Reference: TB 0194 (10/2025)

Technical Bulletin

Installation: Gas and oil boiler pitched roof flashing kit

INCORRECT INFORMATION FOR FLASHING KIT PART NUMBERS 7716191091 AND 7716191100

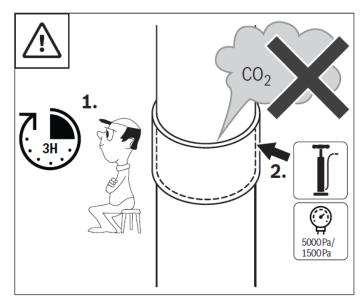
When installing a vertical flue for any gas or oil boiler that is using a vertical flue with a pitched roof flashing kit (part numbers above), we advise that the installation instructions are adhered to. There is however, a step included in the flashing instruction which shows a pressure test of the flue. This is **not** a requirement for UK installations.

The figure below shows the installation step that does not need following:

The manual will be updated in due course.
